UNITED STATES PATENT AND TRADEMARK OFFICE

APPLICATION NO.	FILING DATE	FIRST NAMED INVENTOR	ATTORNEY DOCKET NO.	CONFIRMATION NO.
10/538,008	06/03/2005	Tomoyoshi Yamashita	047991-5019	6861

Office Action Summary	Application No. 10/538,008	Applicant(s) YAMASHITA ET AL.	
	Examiner ROBERT MAY	Art Unit 2885

DETAILED ACTION

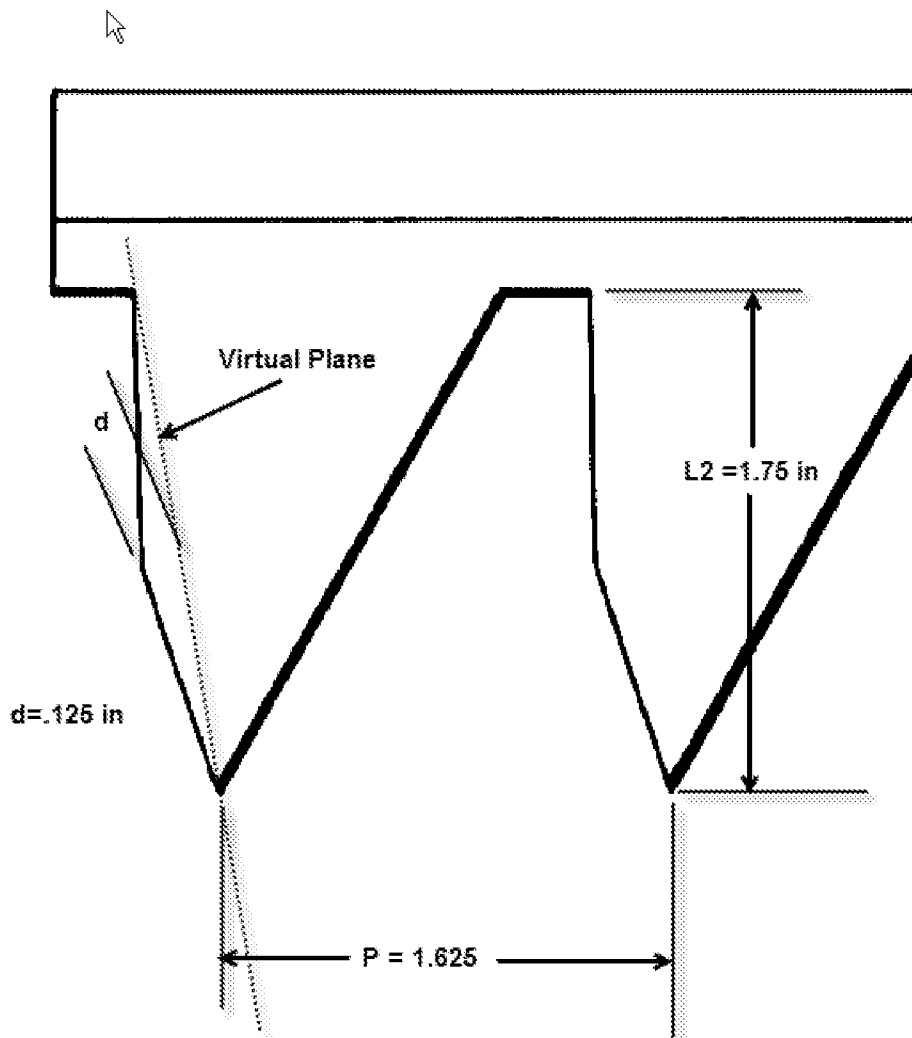
Regarding Claim 12, Miyashita fails to disclose the light deflector as claimed in claim 1, wherein a ratio (d/P) of a maximum distance (d) from the non-single planar surface to a virtual plane connecting a vertex and a bottom of each of the elongated prisms to each other relative to a pitch (P) of the elongated prisms is 0.4 to 5% (instead discloses the $d/P=7.6\%$ see the annotated Figure 16 below)

each other in a cross section thereof as to the second prism face 213a, 213b of each of the elongated prisms shows a relationship of $L2 / P = 1.1$ to 1.7 ($L2 = 1.75$ in and $P = 1.625$, therefore $L2/P$ is approximately equal to 1.1 , see the above annotated Figure 16).

It would have been obvious to one of ordinary skill in the art at the time the invention was made to adjust the distance d in relation to the pitch P so that d/P lies within the range 0.4-5% as claimed to adjust the directionality of the light to meet the particular directional requirements of the apparatus, since it has been held by the courts that, where the only difference between the prior art and the claims was a recitation of
